**GE Energy
Nuclear**

NEDO-33330
Class I
eDRF 0000-0067-1515
September 2007

LICENSING TOPICAL REPORT

Advanced Boiling Water Reactor (ABWR) Hydrogen Recombiner Requirements Elimination

Figure 2.14.8 Flammability Control System

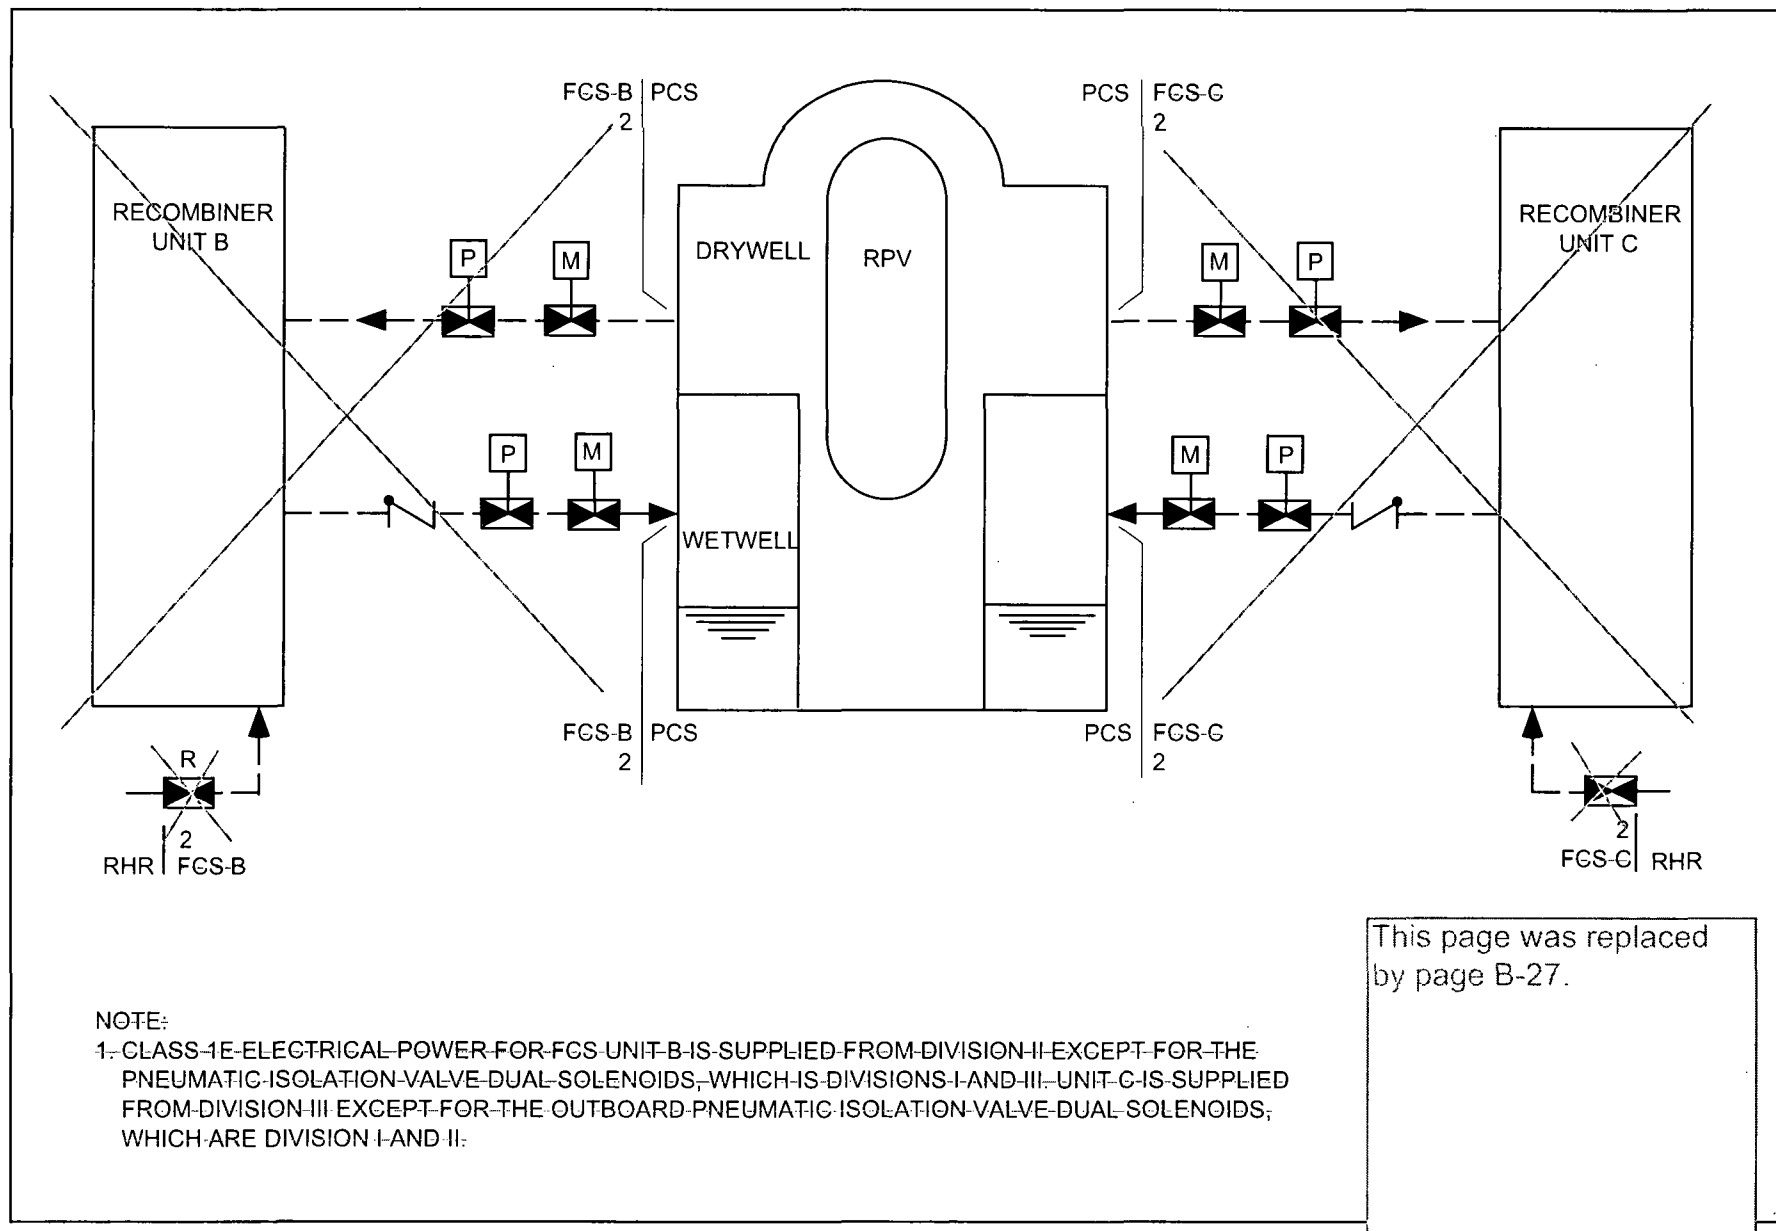
~~The check valves (CVs) shown on Figure 2.14.8 have active safety related functions to both open and closer under system pressure, fluid flow, and temperature conditions.~~

~~The pneumatic valves shown on Figure 2.14.8 fail to the closed position in the event of loss of pneumatic pressure or loss of electrical power to the valve actuating solenoids.~~

~~Inspections, Tests, Analyses and Acceptance Criteria~~

~~Table 2.14.8 provides a definition of the inspections, tests, and/or analyses, together with associated acceptance criteria, which will be undertaken for the FCS.~~

FIGURE 6.2-40 FLAMMABILITY CONTROL SYSTEM P&ID (Sheet 1 of 2)
ABWR DCD/Tier 2 Rev. 0 21-123

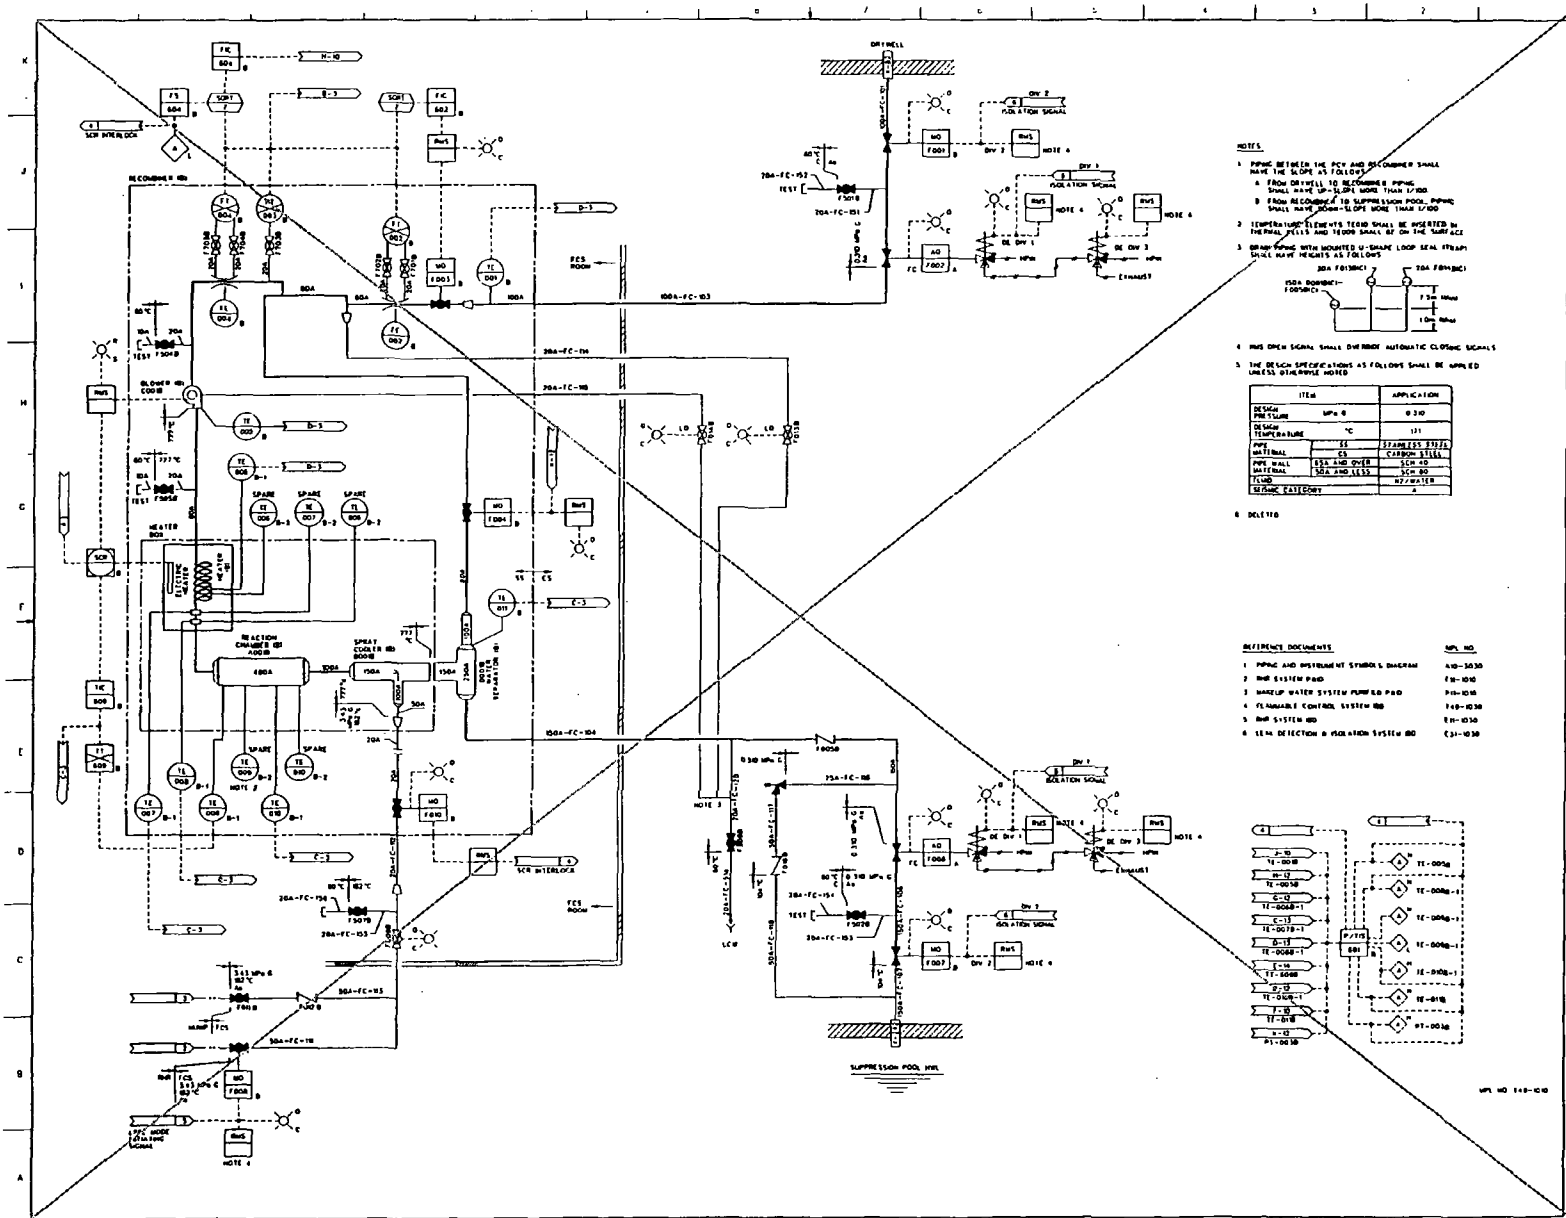
The changes described in this LTR are to Tier 1 and Tier 2 of the ABWR DCD Revision 4. This includes the piping and instrumentation diagram (Figure 6.2-40) changes that are marked in Appendix C.

~~Figure 6.2-40 Flammability Control System P&ID (Sheets 1 – 2)~~
